Access Compliance Report

Public Rights-of-Way

(Curb Ramps)

Intersection ID: 21797	Main Street: GALLERIA_BV	Cross Street: MONROE_RD	Location: SW
ADA ID: CA8F751D9078	Ramp Type: Perp	Initial Pass/Fail: Fail	Overall Compliance: No
		Severity Score: 12.5

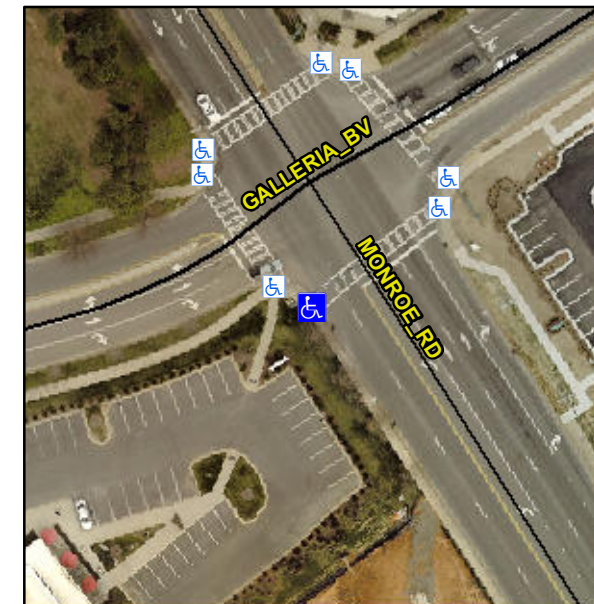
Not Found, R304.2.2

Compliance	Description	Data	Compliance	Description	Data
N/A	Ramp Length (in)	24.5	No	Ramp Slope (%)	8.6
Yes	Ramp Width (in)	48.0	Yes	Ramp XSlope (%)	1.6
N/A	Flare Type LT	N/A	N/A	Flare Type RT	N/A
N/A	Flare Slope LT (%)	N/A	N/A	Flare Slope RT (%)	N/A
N/A	Flare Traversable LT?	N/A	N/A	Flare Traversable RT?	N/A
N/A	Landing Length (in)	N/A	N/A	DWS Provided?	N/A
N/A	Landing Width (in)	N/A	N/A	DWS Contrast?	N/A
N/A	Landing Slope (%)	N/A	N/A	DWS Length (in)	N/A
N/A	Landing X Slope (%)	N/A	N/A	DWS Full Width?	N/A
N/A	Landing Curb? (Y/N)	N/A	N/A	DWS Offset (in)	N/A
N/A	Shared Landing?	N/A			
N/A	Gutter Ponding?	N/A	N/A	Gutter Slope (%)	N/A
N/A	Gutter Lip Ht (in)	N/A	N/A	Gutter X Slope (%)	N/A
N/A	Painted X Walk1?	Yes	N/A	Painted X Walk2?	N/A
	X Walk 1 Direction	To NE		X Walk 2 Direction	N/A
N/A	X Walk 1 Width (in)	104.0	N/A	X Walk 2 Width (in)	N/A
	X Walk 1 Slope (%)	3.1		X Walk 2 Slope (%)	N/A
	X Walk 1 X Slope (%)	1.8		X Walk 2 X Slope (%)	N/A

Remove & Replace Entire Ramp.
